## Roadster 2013 ST Upper Belt Guard Falling Off

**Summary:**

BRP has received reports concerning 2013 ST model upper belt guards falling off. This only affects 2013 models.

A. 705007213 upper belt guard

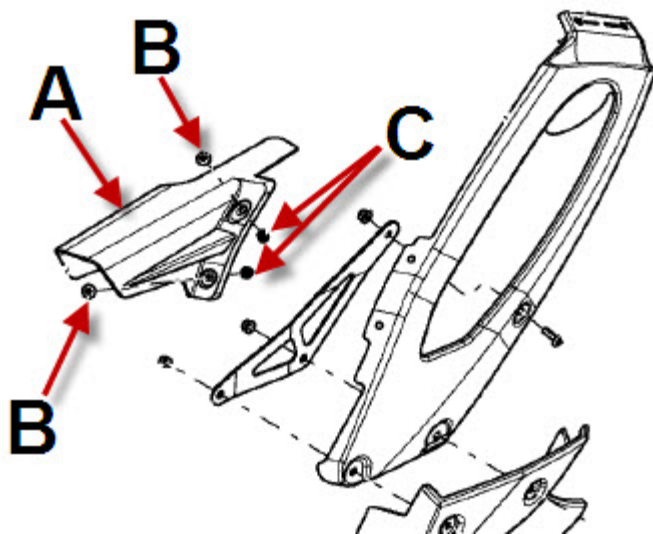
The problem has been identified as being the Torx screws being too short and not reaching the nylon of the nut. At the present time the MY13 parts catalog does not show the correct Torx screw, this will be corrected.

B. ~~250000349 Torx Screw M6x10~~ --> 250000454 Torx Screw M6x12 (X2)

If the belt guard has fallen off and needs to be replaced, order all parts above.

If you want to be proactive and replace the screws, order the correct screws since the nut's nylon has not been touched.
